URGENT FIELD SAFETY NOTICE

FSCA Reference: 1427918 - Bubble Sensor - Bad contact in sensor cable

Affected Product: BS 3/8x3/32 L1.7 Mat. 701055720
(Bubble Sensor for 3/8" x 3/32" tubing, length 1,7 m)

Figure 1 Picture of a Venous Bubble Sensor

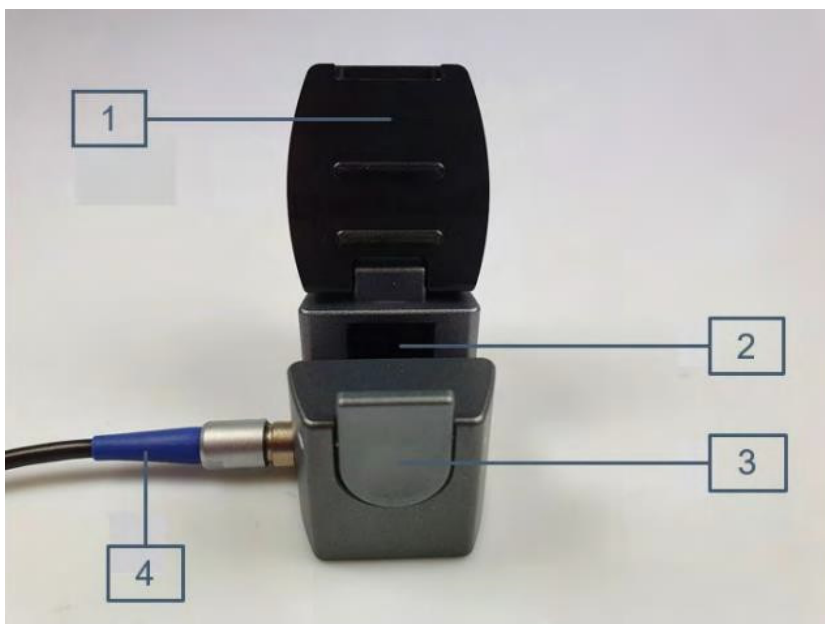
Internal investigations have identified an issue with the durability of the connecting cable (See Fig. 1 position [4]) near the connection to the Bubble Sensor. Excessive bending of the cable can lead to poor contact, which may trigger the errors "Ven. bubble sensor defective" or "Ven. bubble sensor disconnected" on the connected medical device (ROTAFLOW II or CARDIOHELP-i). These errors can occur temporarily when the cable is moved or permanently if the connection is fully compromised.

- The Venous Bubble Sensor remains functional until error ("Ven. bubble sensor defective" or "Ven. bubble sensor disconnected") displays on the main device.
- To prevent error occurrence please follow these guidelines when handling Venous Bubble Sensors:
 1. **Avoid roll up or coiling of the sensor cable!** When storing affected products, place them loosely in a box or bag to prevent damage.
 2. **Avoid excessive bending** of the Venous Bubble Sensor.
 3. **Handle the Sensor cable with care during cleaning.** Do not pull with excessive force while wiping the cable.
